Nature of Project:
Construct addition; alter fence;
construct deck

APPLICATION FOR A CERTIFICATE OF APPROPRIATENESS – STAFF REPORT

COA-0009-2020 906 W LENOIR STREET

A01-03

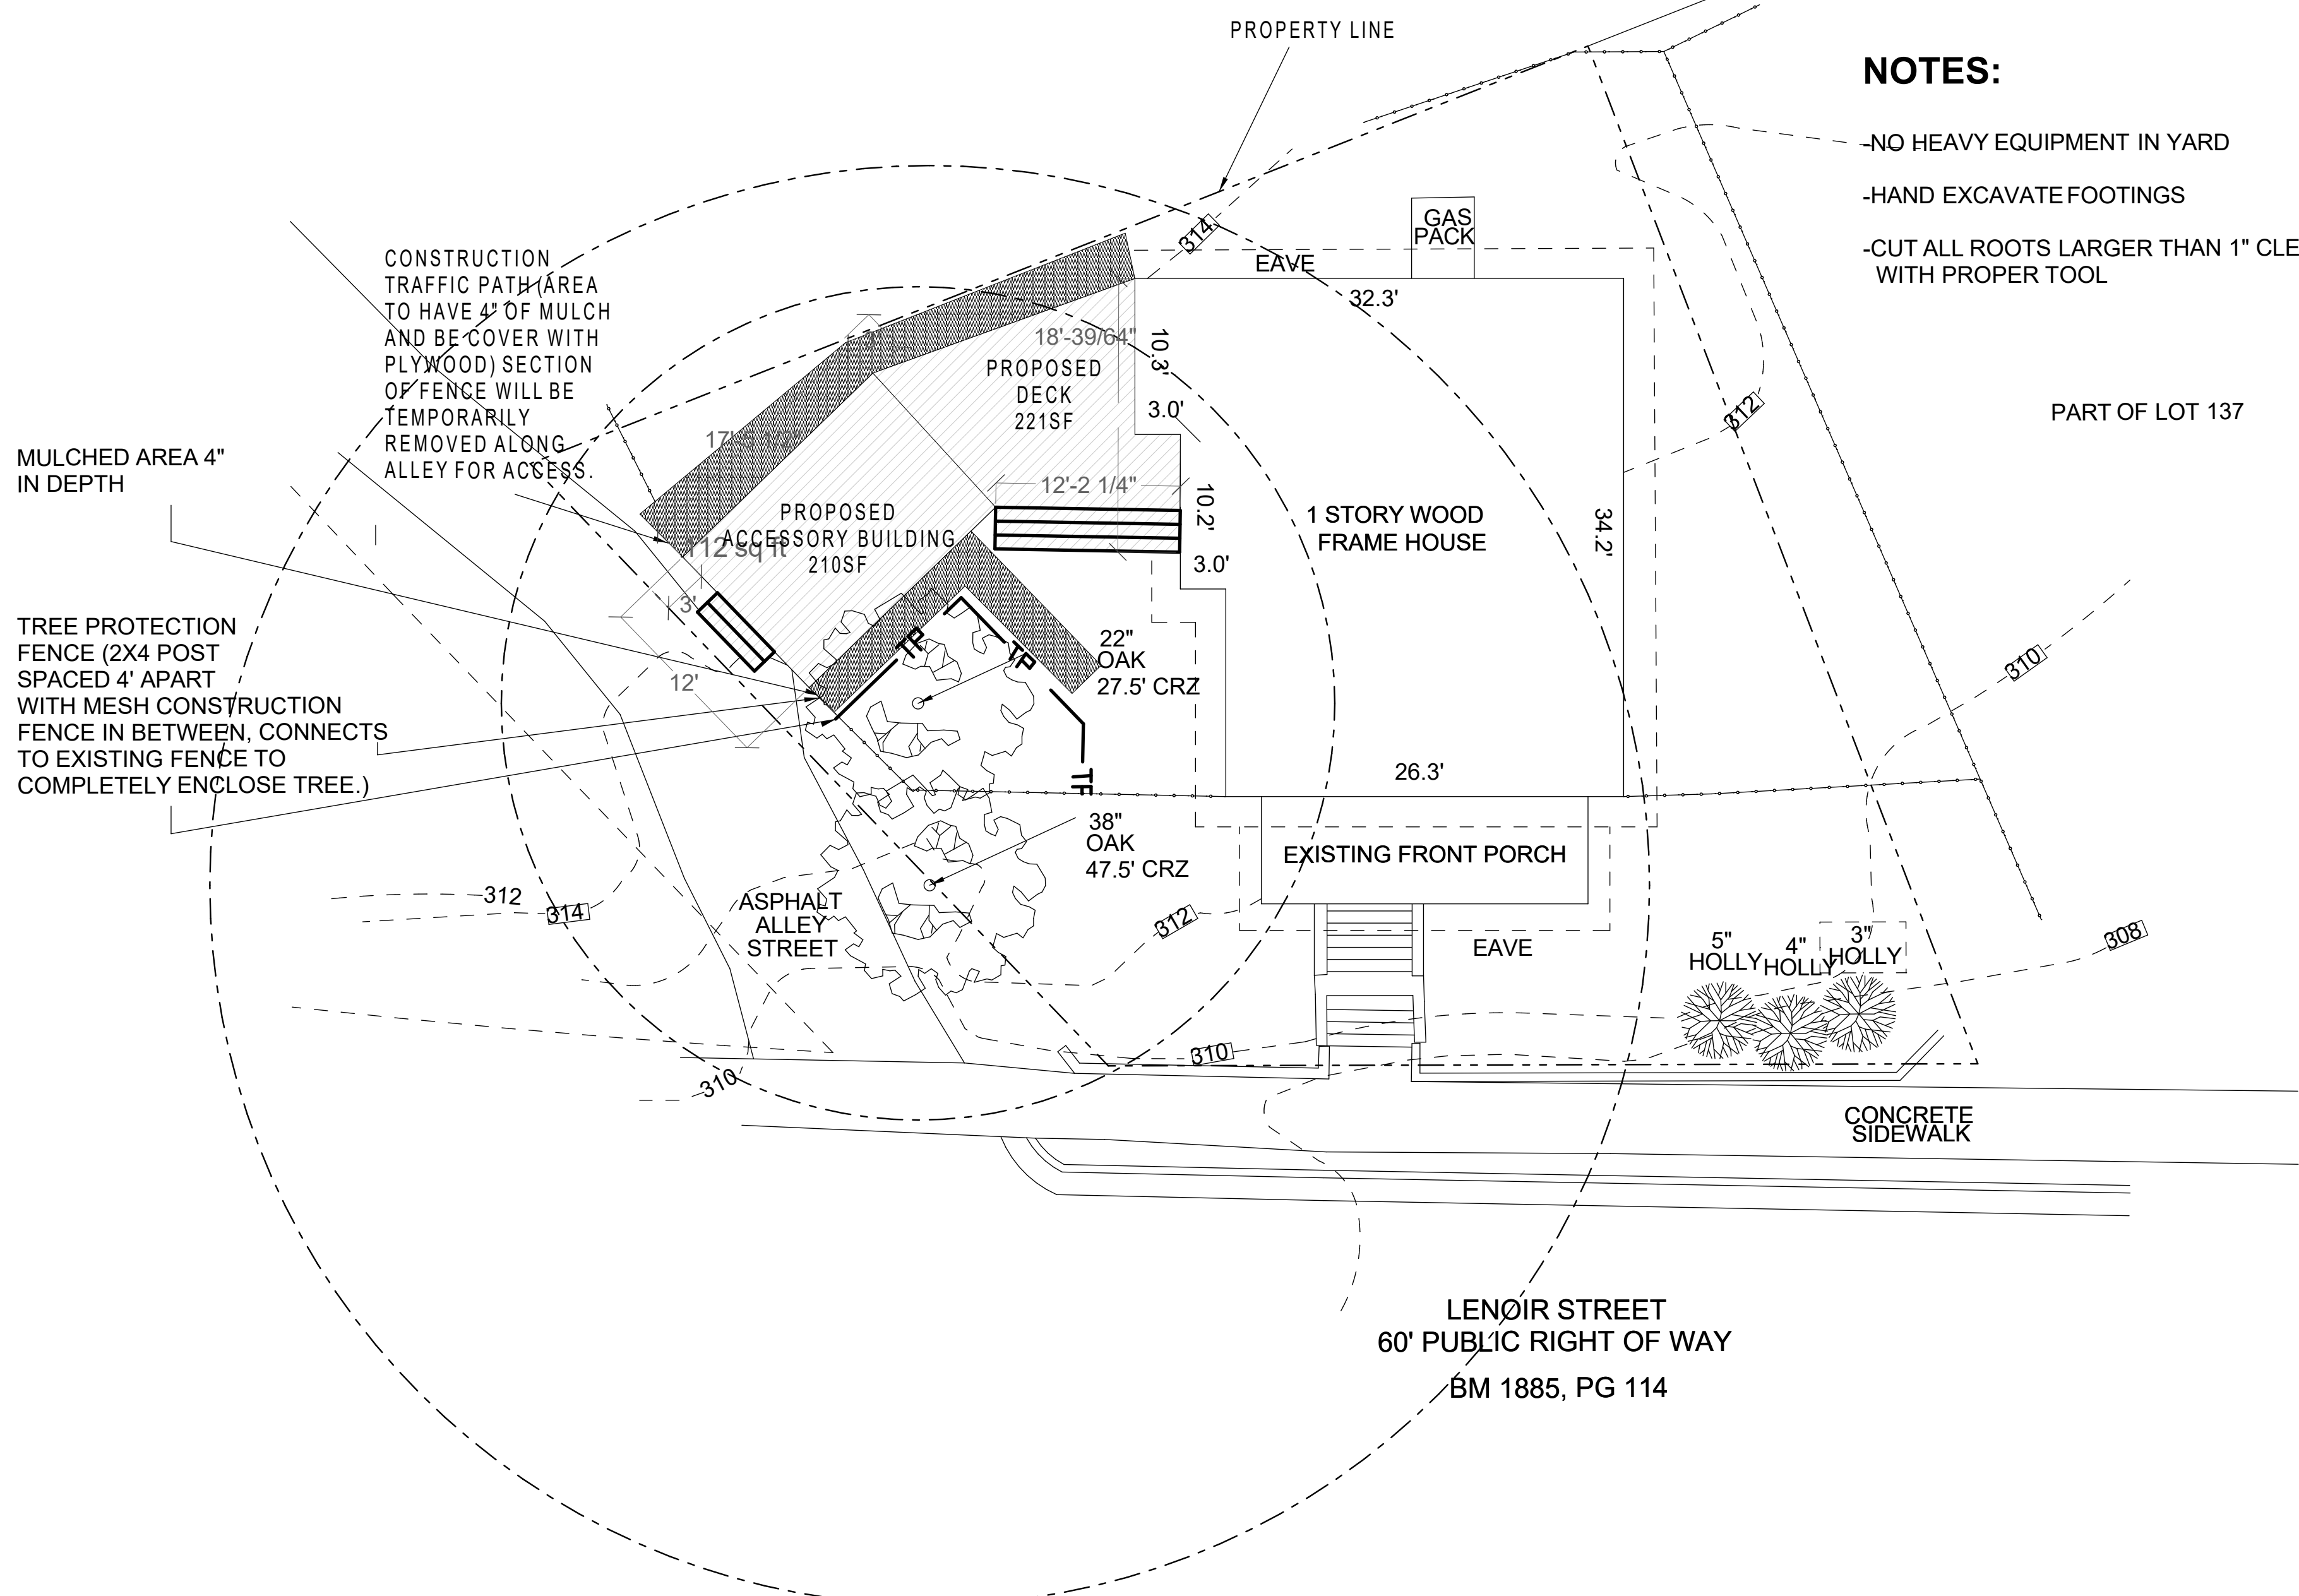
- 1* The proposed shed is sited along the alley. The proposed location is sited traditionally along the alley; however, due to the atypical siting of the house, the proposed location is in the side yard, set back approximately 6' from the line of the front wall of the house.

- 2* The proposed accessory structure is located about 12' from the west façade of the primary structure. This places the shed 3' from the rear property line.

- 3* The proposed shed is 12' x 17.5'. The accessory structure is connected to the primary structure by a wood deck. The proposed deck is an irregular rectangle, approximately the same dimensions as the proposed shed.

Staff recommends that the committee discuss the location of the shed. Should the committee choose to render a decision, staff suggests that the committee approve the application with the following conditions:

1 TREE PROTECTION PLAN
A01-04 SCALE: 1/8" = 1'-0"

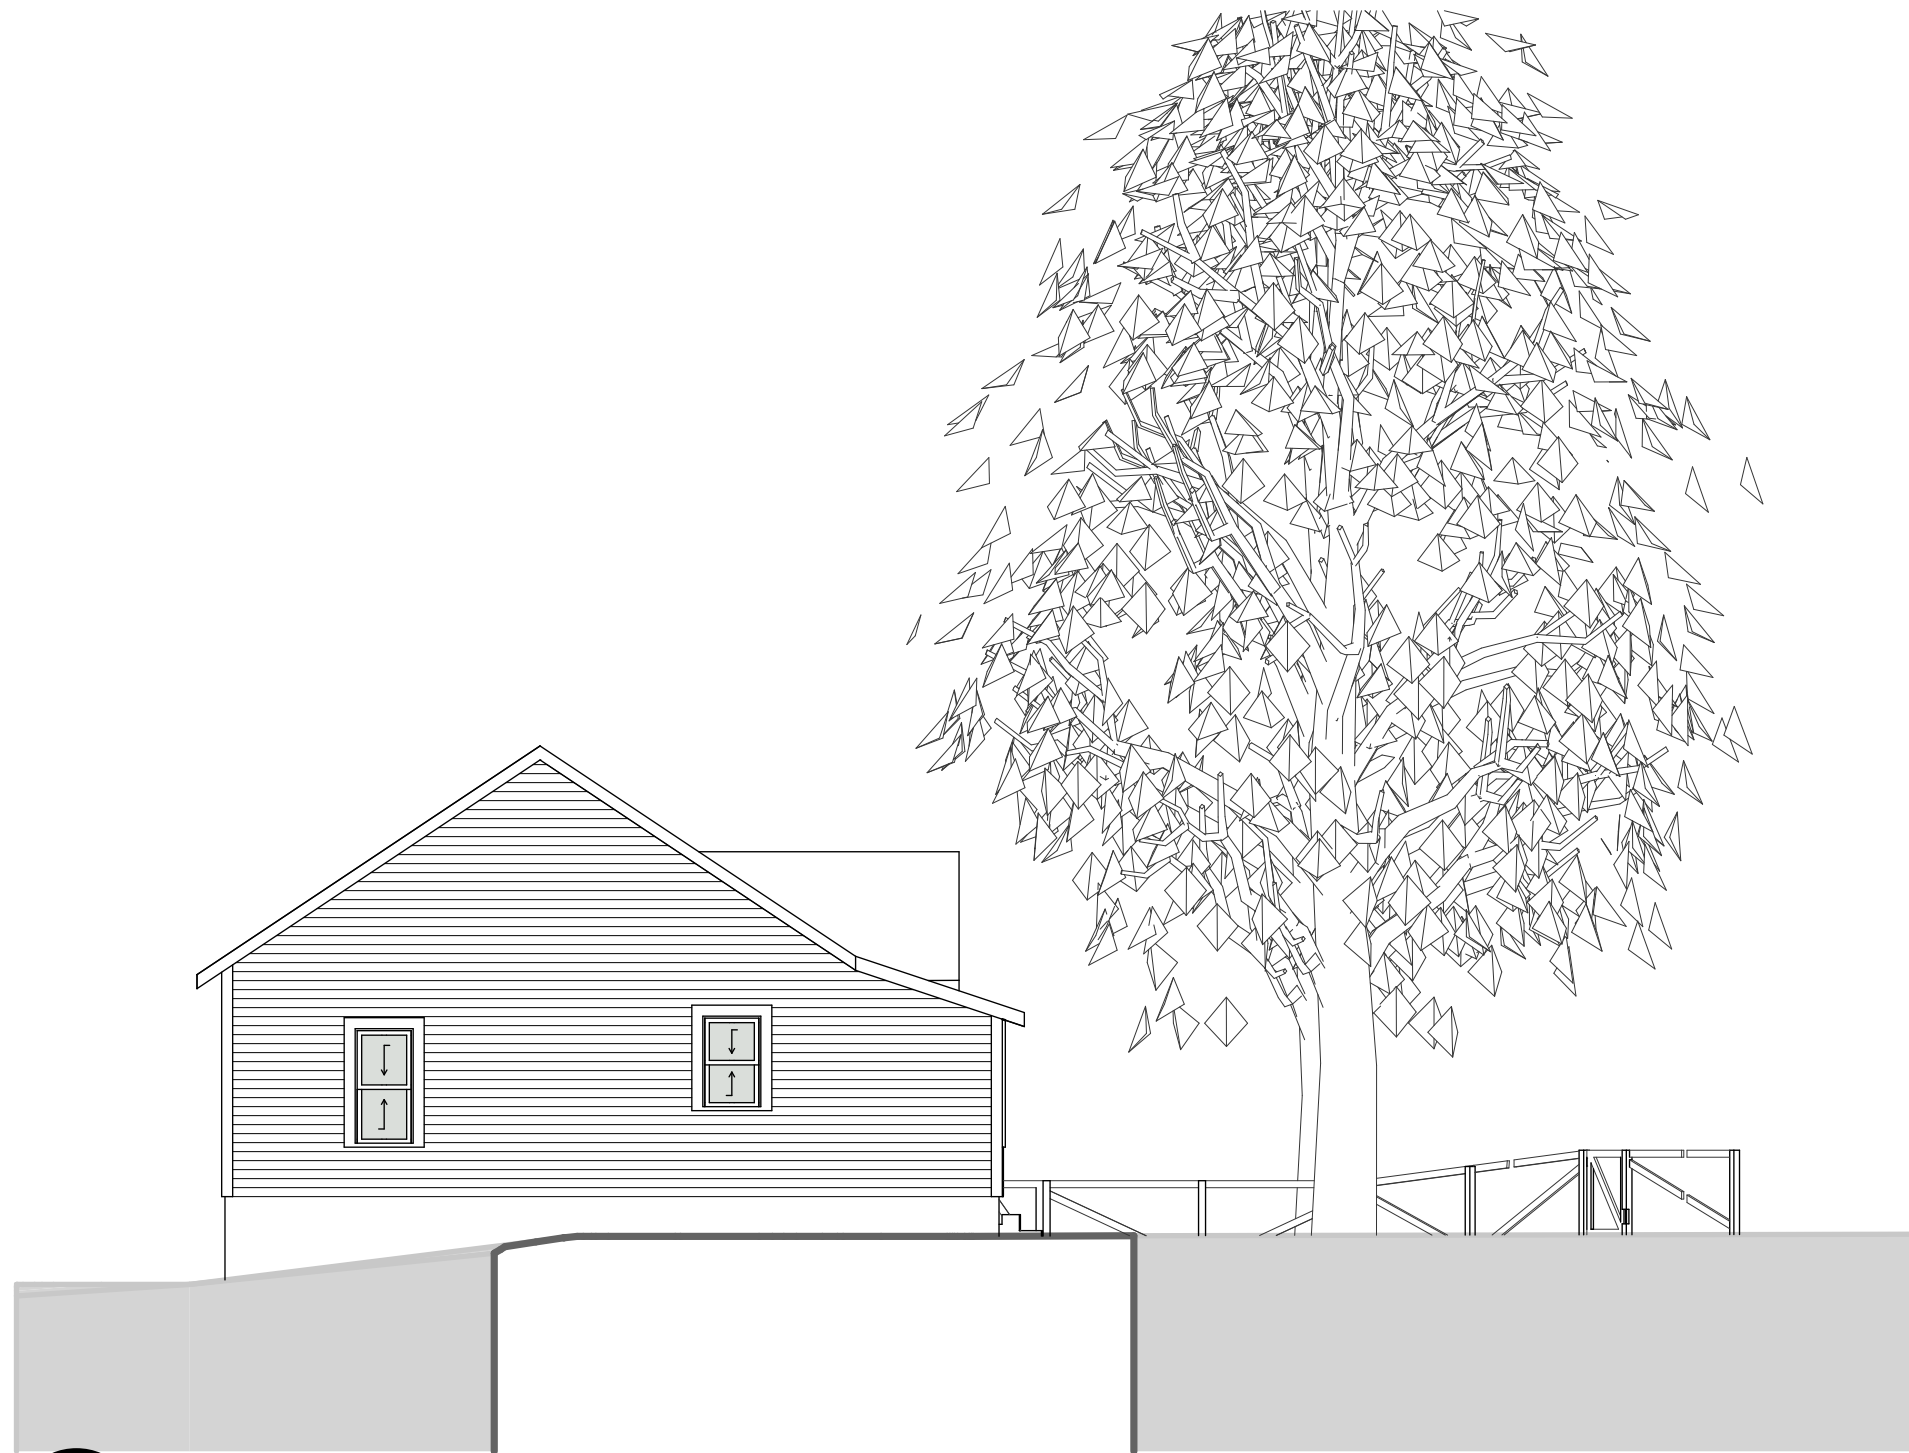
15* There is a large tree immediately adjacent the shed. A tree protection plan was provided.

1. That tree protection plans be implemented and remain in place for the duration of construction.
2. That details and specifications for the following be provided to and approved by staff prior to issuance of the blue placard for the addition:
 - a. Window trim details;
3. That details and specifications for the following be provided to and approved by staff prior to installation or construction:
 - a. Paint color;
 - b. Manufacturer's specifications for exterior lighting, and location on building, if any.
